MODIFICATION TO AMEND STAGE 3 OF MASTERPLAN (MP06_0046 MOD 3)

Please find attached a copy of the report and recommendations endorsed by Council at its meeting of 12 April 2011 in relation to modifications requested by Becton under stage 3 of the Bonnyrigg Living Communities Project.

47: Issue: Bonnyrigg Living Communities Project – Modification to Concept Plan – Stage 3.
Premises: Bonnyrigg Housing Estate, Bonnyrigg.
Owner: Fairfield City Council, Department of Housing.
Applicant: Becton Pty Ltd (Attachment A)
Zoning: Residential 2(b).
Submissions: No
File Number: 09/02883

FIGURE 9 – STAGE 3 BOUNDARY (CURRENT AND PROPOSED)

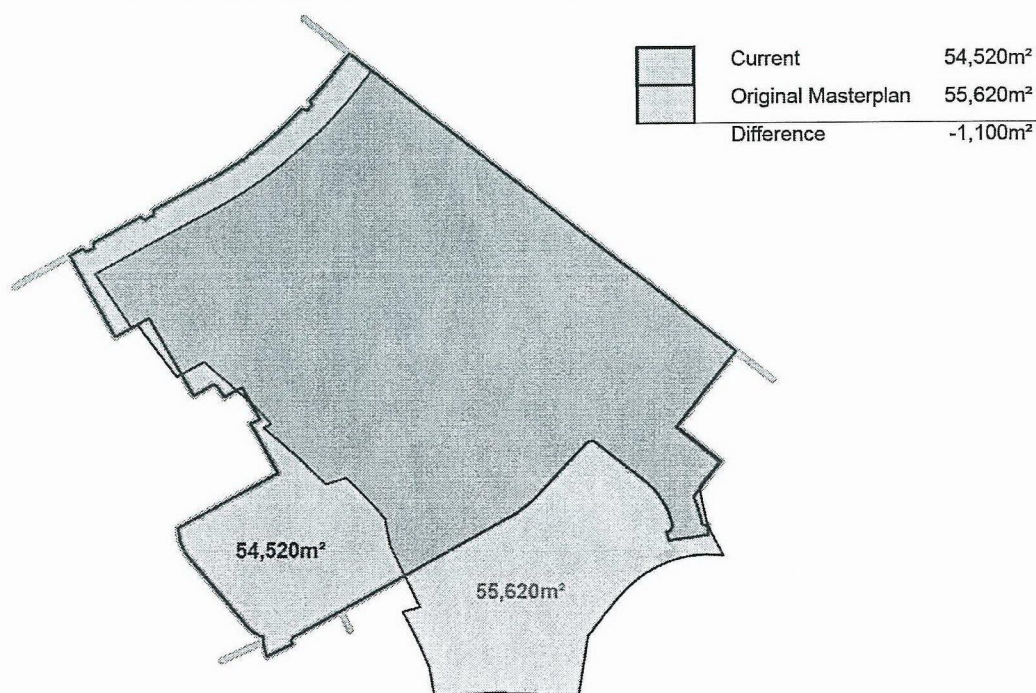
It is also noted that under Stage 2 of the proposal, the applicant received support from the Dept of Planning to decrease the minimum lot width for dwellings from 9.5m to 8.5m, with the current proposed minimum for stage 3 of 6.4m. Issues and concerns in relation to this additional reduction are discussed further in this report.

The Stage 3 development application seeks to vary from the indicative staging boundary shown on the Indicative Staging Plan. The proposed modification is required to provide an interface between Stage 3 and public open space, addressing the locational requirements for neighbourhood apartments in accordance with the amended Masterplan. However, the proposed modification to the staging boundary will result in only a minor change to the original area of this stage, as demonstrated in **Figure 9**.

FIGURE 19 – ON-STREET CAR PARKING SPACES (STAGE 3)

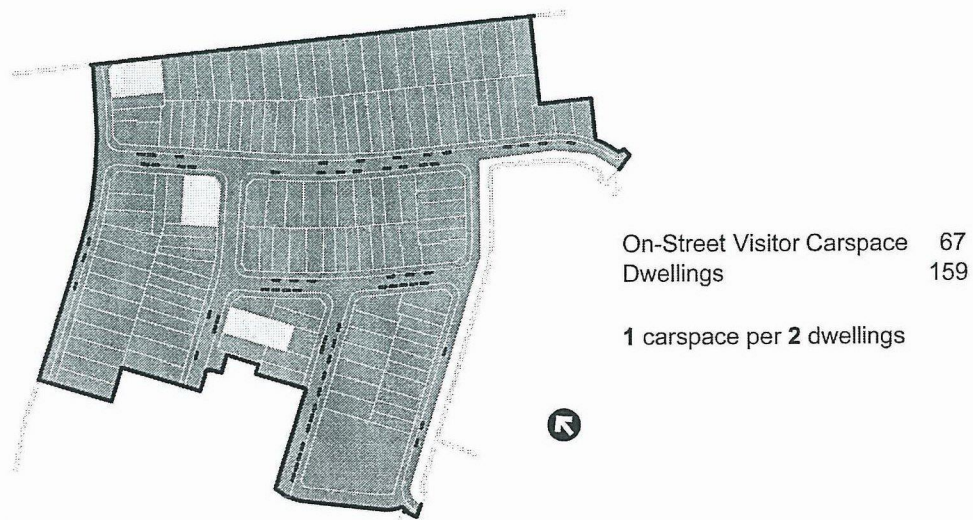
Based on a plan submitted by the applicant, not all the on-street visitor car parking in Stage 3 is provided evenly throughout the development. In some instances there is also clustering along some streets in the visitor car parking creating an obstacle to the free flow of traffic and service vehicles. In addition, on-street visitor car parking is not conveniently available to all parts of the Stage 3 housing.

If the Department does not support Council's request to review the Concept Plan, it is recommended the applicant be required to review the level of on-street visitor car parking in Stage 3 to make this more evenly distributed and to avoid cluster points that impede the movement of traffic and service vehicles, particularly garbage trucks.

Diagrams indicating the capacity of each stage to accommodate on-street car parking are provided as **Figure 17, Figure 18 and Figure 19**. The average amount of on-street car parking will vary from stage to stage, having regard to the retention of the existing local roads and the delivery of new roads. It is clearly evident that the proposed introduction of the compact lots and walk-up apartments will not result in a reduction in the amount of car parking, taking into account:
